CARTRON BIG HISTORIC LANDFILL - H0302-01

RESPONSE TO REQUEST FOR INFORMATION

Prepared for: Longford County Council

Drawing requested under
Point 9

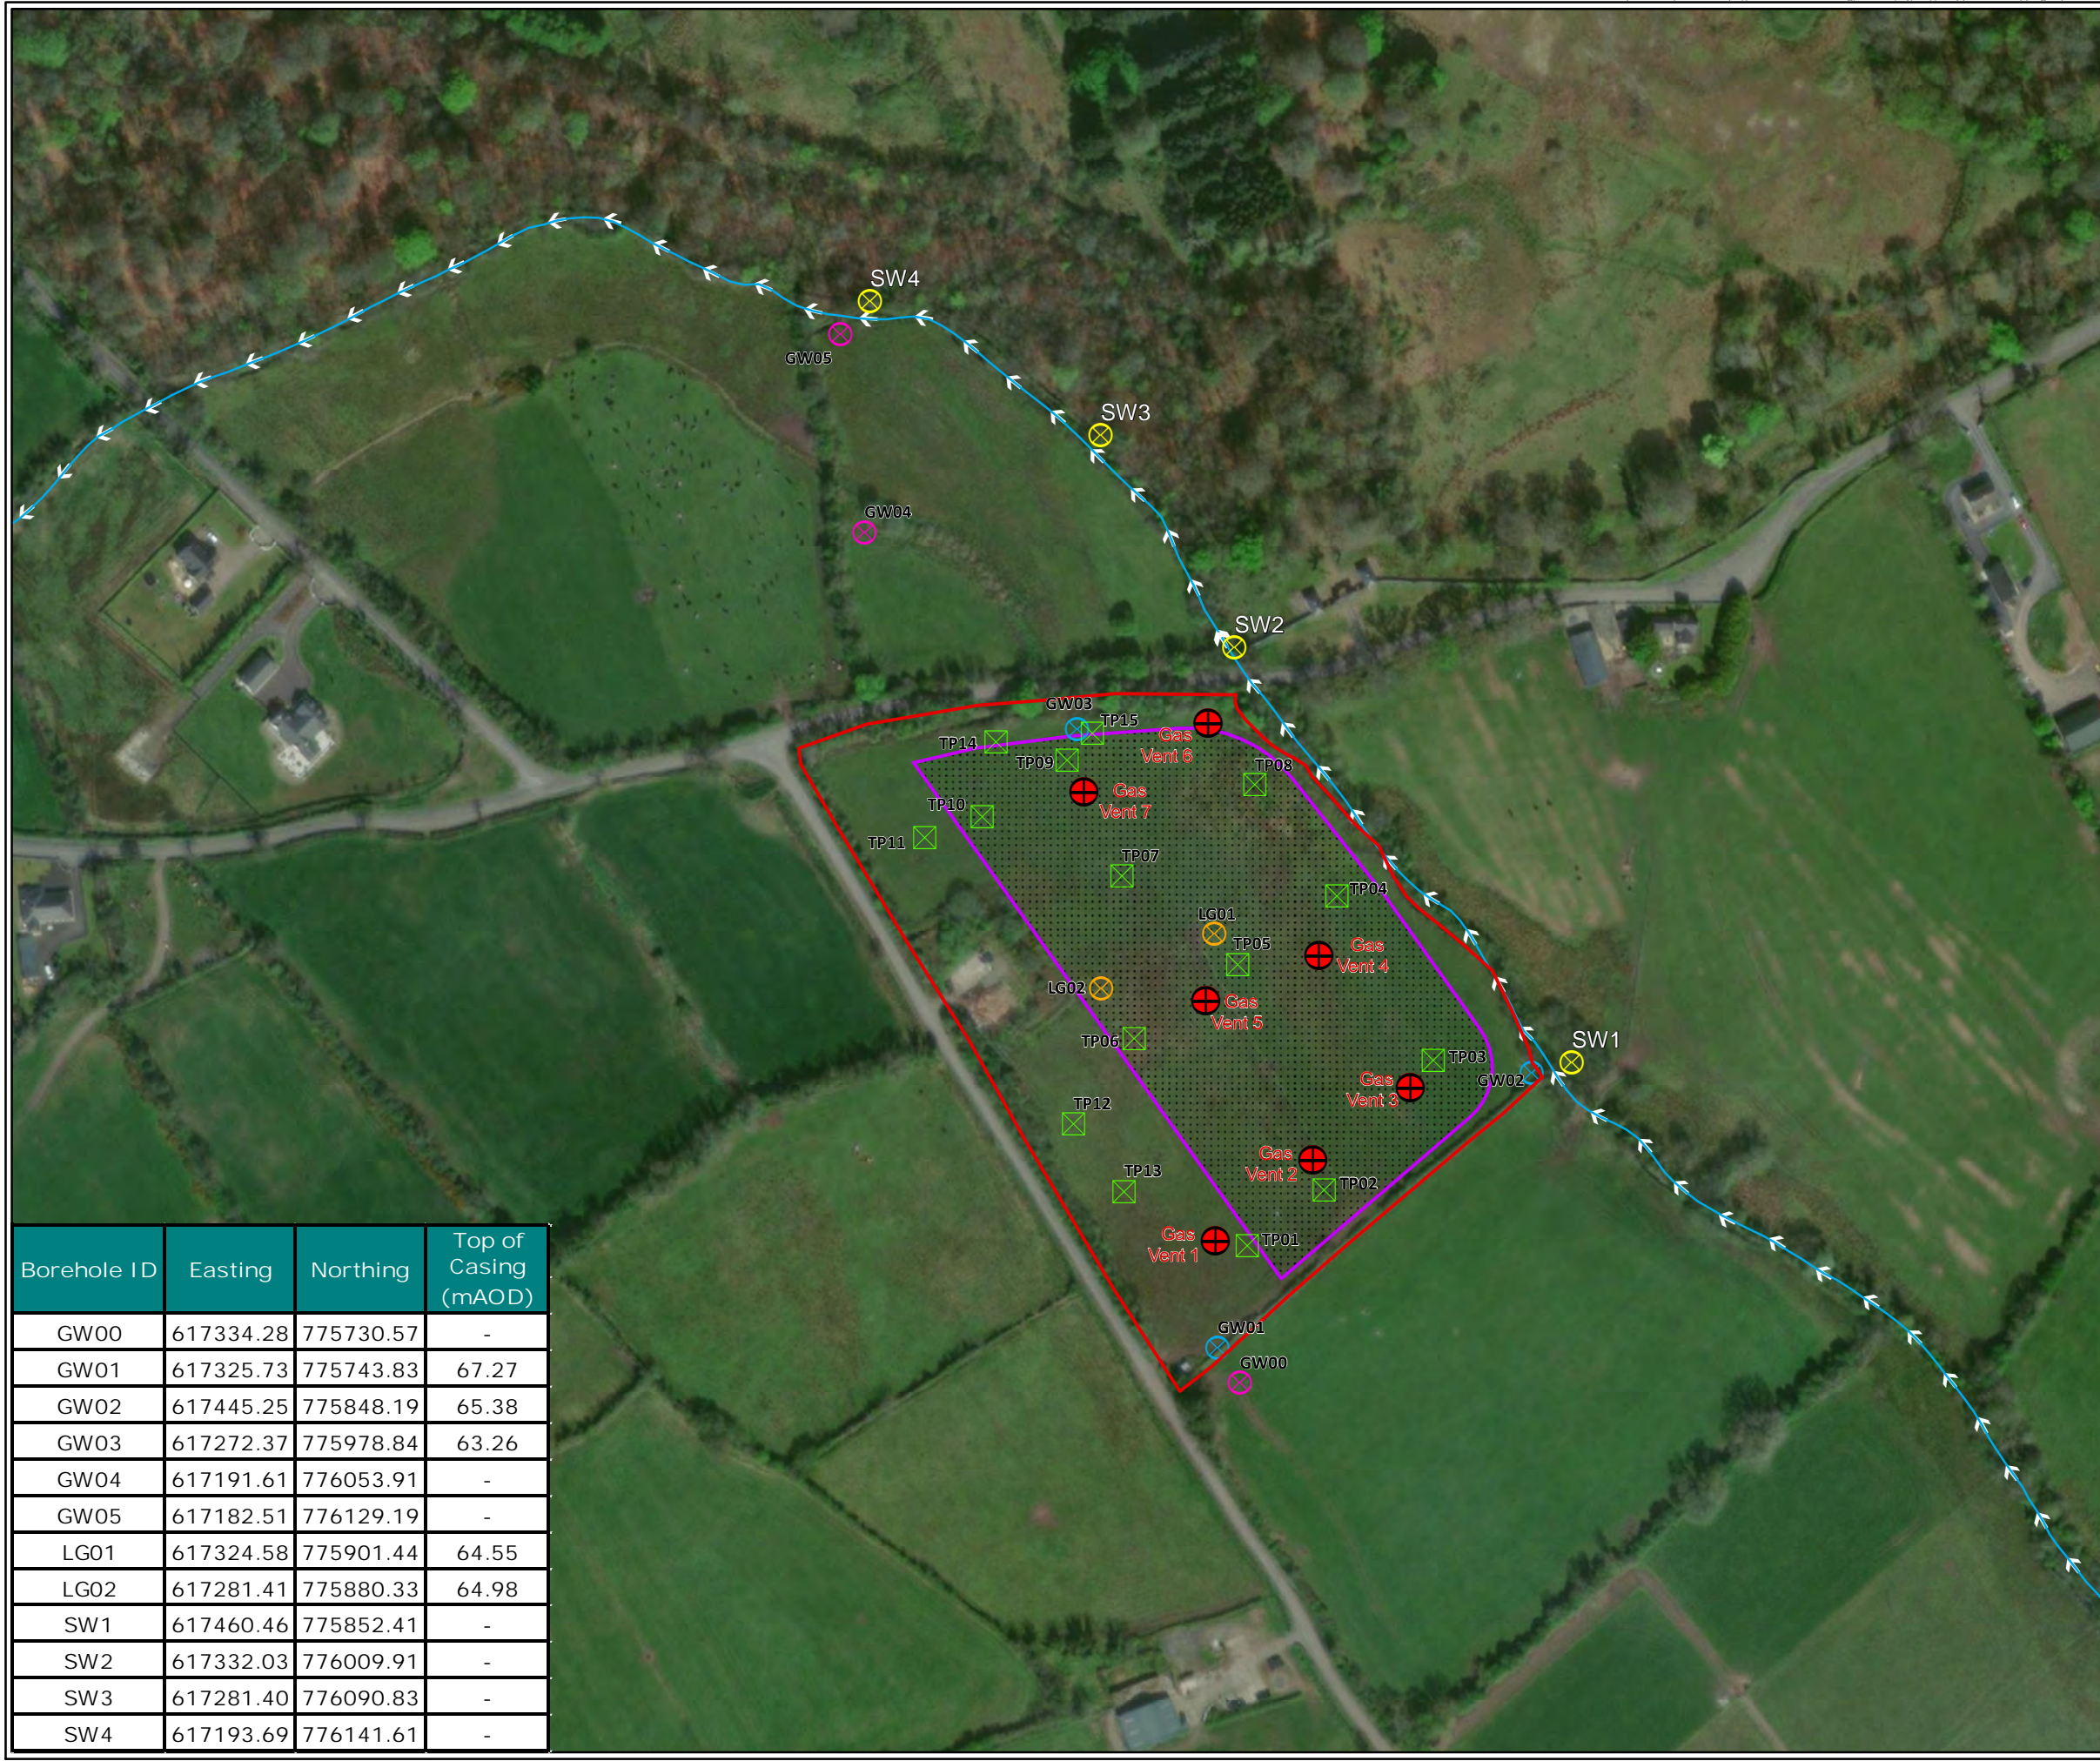
Section 3.1.2 of the Tier 3 Assessment states that eight gas vents are installed across the site. Include these gas vents on the Drawing required under Point 9.

- (i) the entire site boundary in red;*
- (ii) the outline of the waste body boundary, in a different colour than red;*
- (iii) the area to be capped, in a different colour than required in Points (i) and (ii);*
- (iv) monitoring locations for leachate, groundwater, landfill gas and surface water;*
- (v) the existing gas vents referred to in Point 2; and*
- (vi) the drainage channels referred to in Point 4.*

The locations of 7 vents are known. The locations of the known vents and have been added to Drawing required under Point 9.

An updated drawing has been prepared as requested.

PROJECT	CLIENT		
CARTRON BIG LANDFILL, LONGFORD	CARTRON BIG		
SHEET	Date	Project number	Scale (@ A3-)
	16.09.22	P22-158	1:###
	Drawn by	Drawing Number	Rev
Checked by	P22-158-0601-0002	A	
	SFM		
	BF

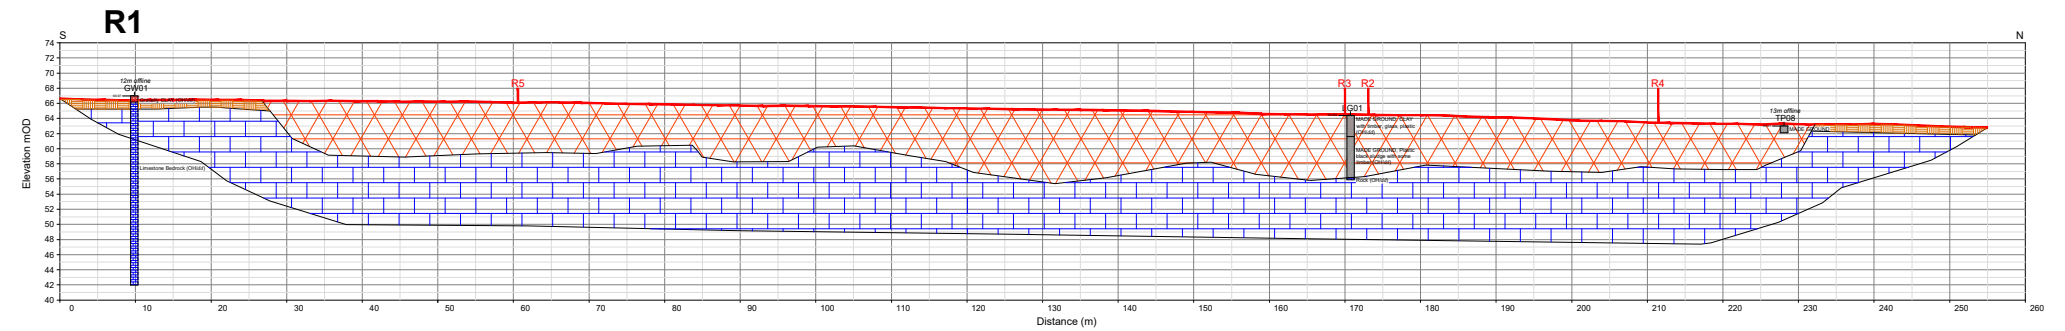
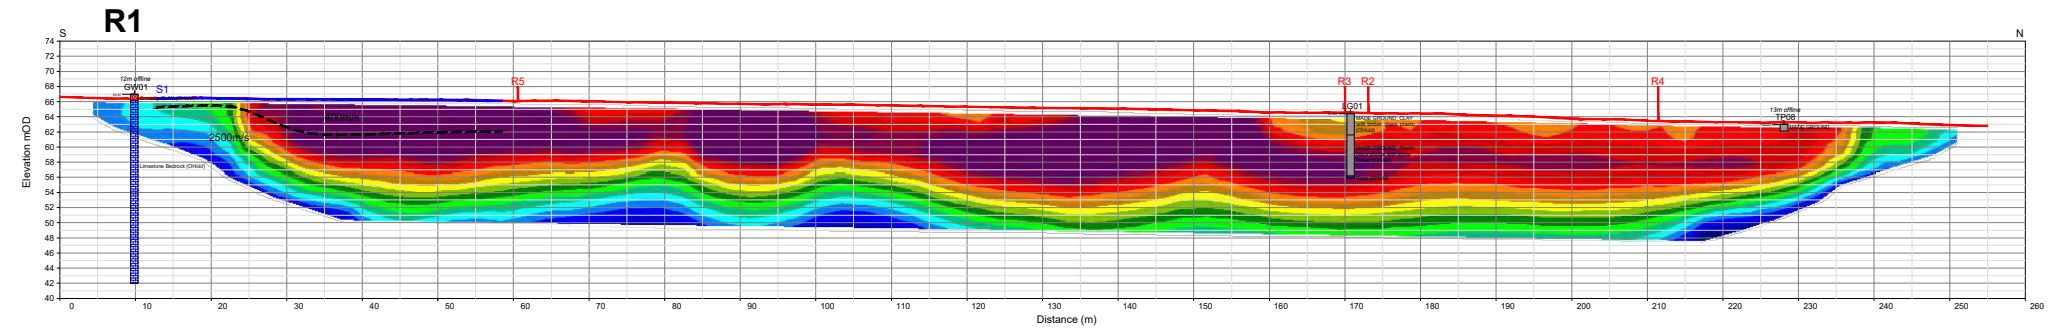
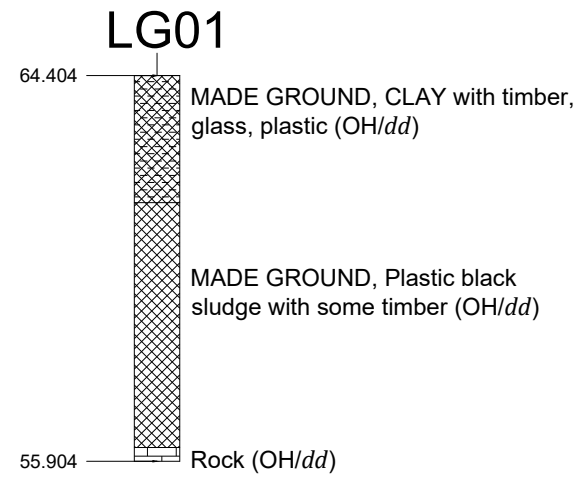
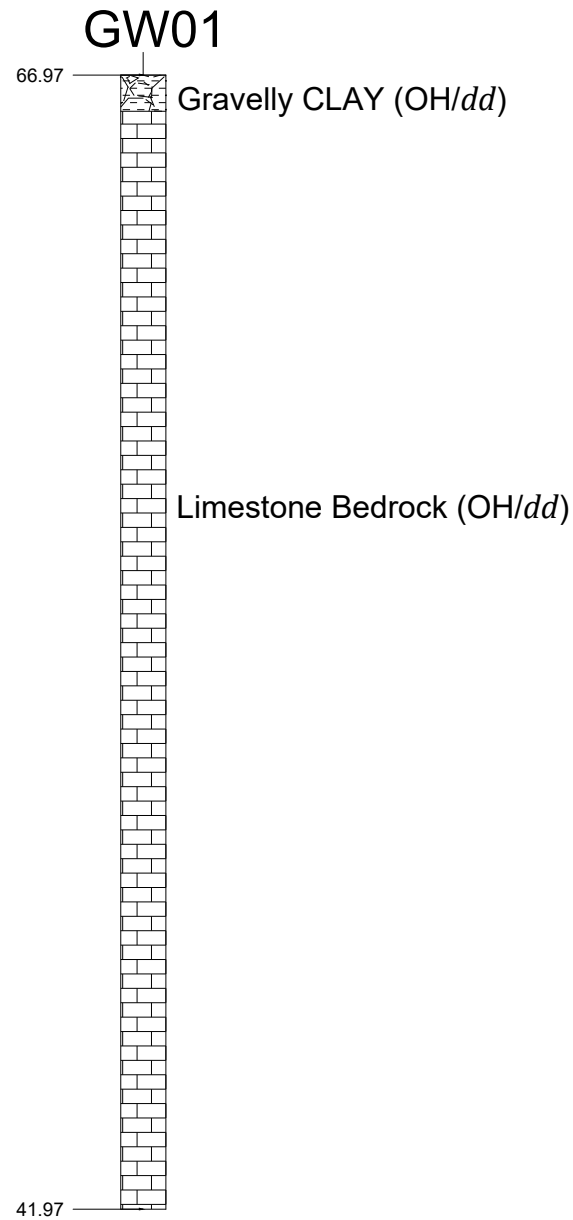
It is noted that the font in the cross-sections of the landfill profiles shown in Drawings No. P18159-GP-D02 to P18159-GP-D06 of the Ground Investigation Report is illegible. Re-submit the drawings with a clear readable font.

Please see Appendix 4 for updated drawings:

- P22-158-0601-0002
- P22-158-0601-0003
- P22-158-0601-0004
- P22-158-0601-0005
- P22-158-0601-0006
